Subject: Dresden Station Units 2 and 3  
Additional Response Concerning  
Fire Protection Modifications  
NRC Docket Nos. 50-237/249

Dresden Station Units 2 and 3  
Response to NRC Staff Requirements  
Concerning Fire Protection

# DRESDEN STATION FIGURE - 1

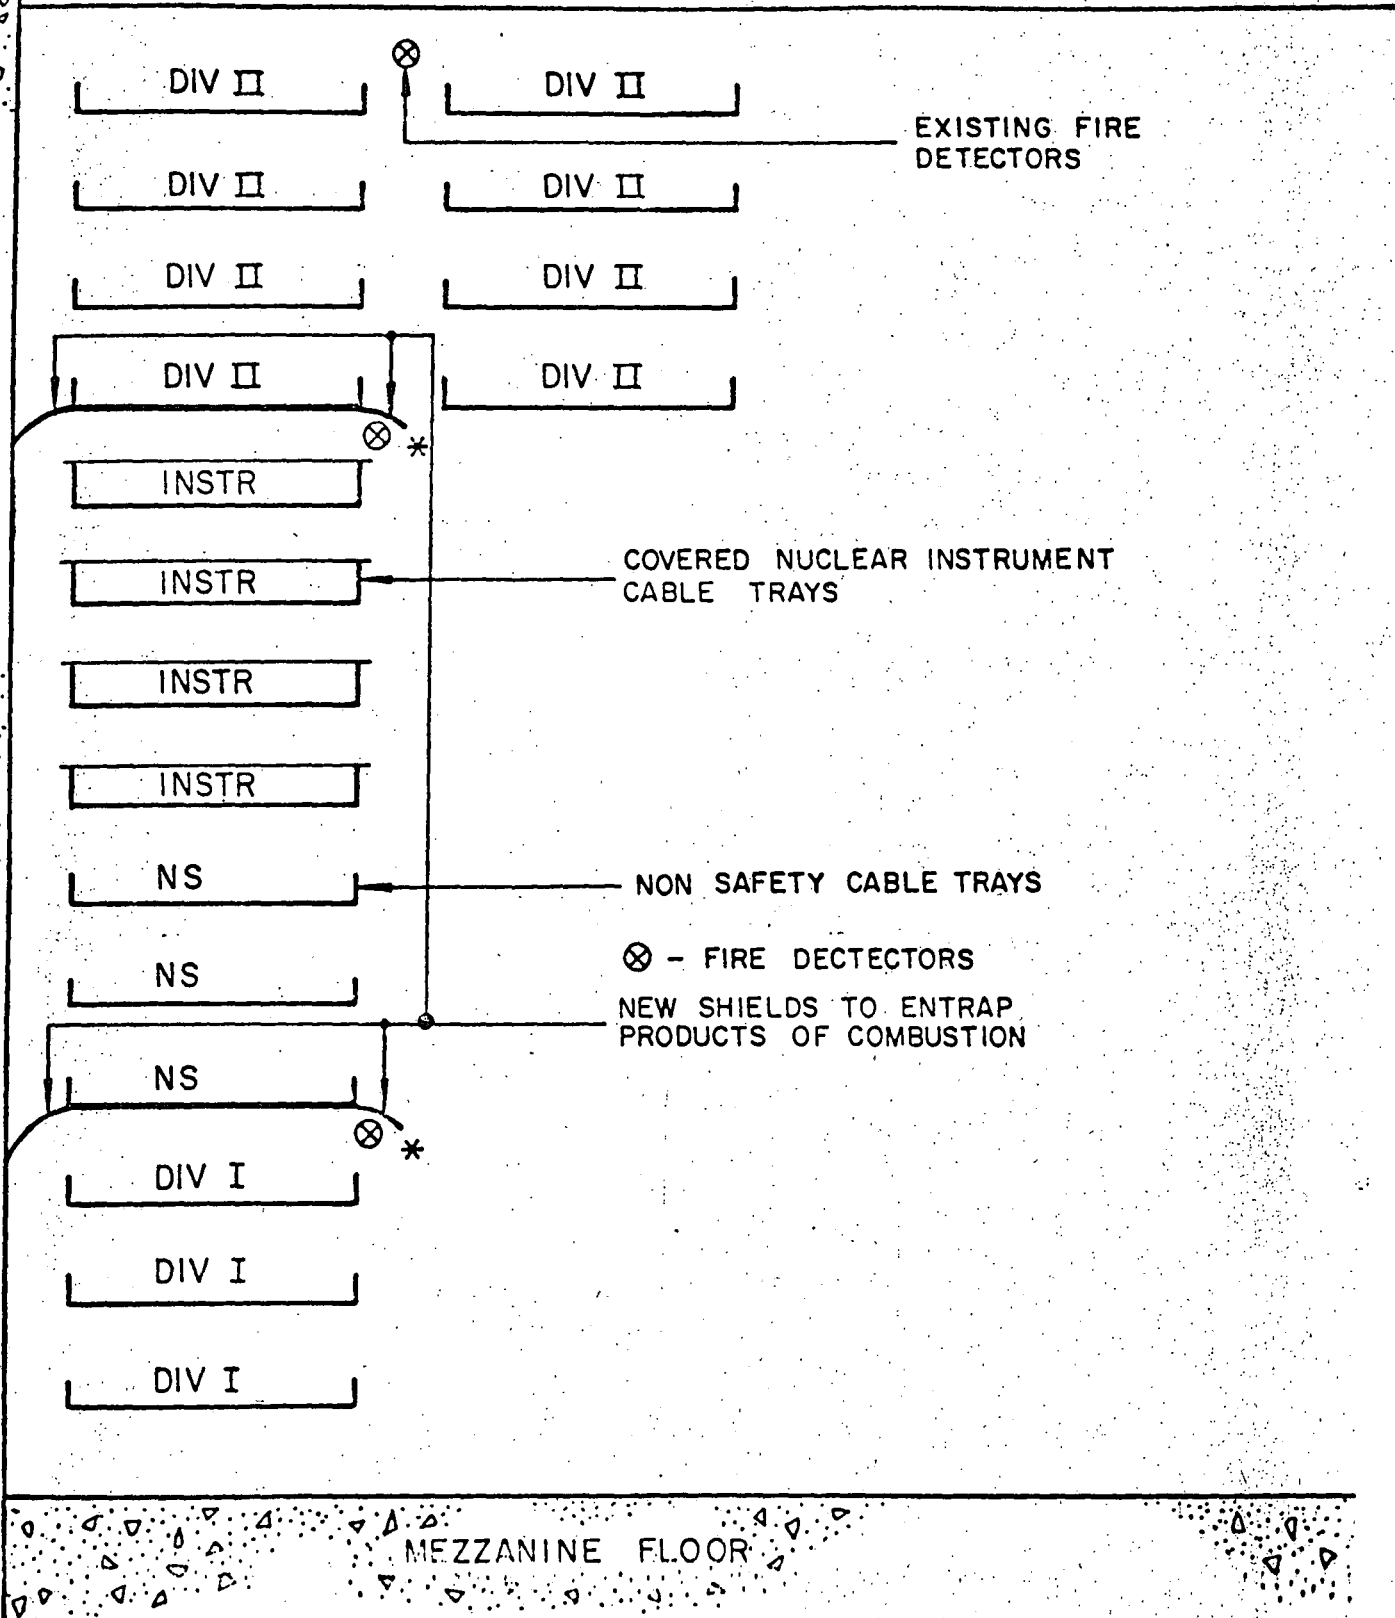
2. Provide line detectors in the cable trays or spot type heat detectors between the horizontal trays for actuation of the pre-action system.

Figure 1 shows the layout of the cable trays along the south wall of the Dresden Unit 2 Turbine Mezzanine Floor. Figure 1 also shows the proposed addition of fire detectors to activate the preaction sprinkler system.

Shields will be placed on the bottom of the 4th tray up from the bottom and on the bottom of the fourth tray down from the top. The shields will extend the length of the trays as they are covered by the sprinkler system.

Fire detectors will be mounted on the under side of the shields at the front of the trays on appropriate centers along the protected length of tray. The shields between the tray and the wall and the shields at the front of the trays will result in a concentration generated in the section of trays below the detectors. The detectors in this configuration will provide early actuation of the preaction system and insure that the system has been charged when the sprinkler system is required.

\* NEW FIRE DETECTORS LOCATED ALONG THE LENGTH OF THE CABLE TRAYS ON THE TURBINE MEZZANINE FLOOR AS APPROPRIATE. THE SHIELDS WILL BE CONTINUOUS FOR THE LENGTH OF THE TRAY FOR THE AREA COVERED BY THE SPRINKLER SYSTEM.
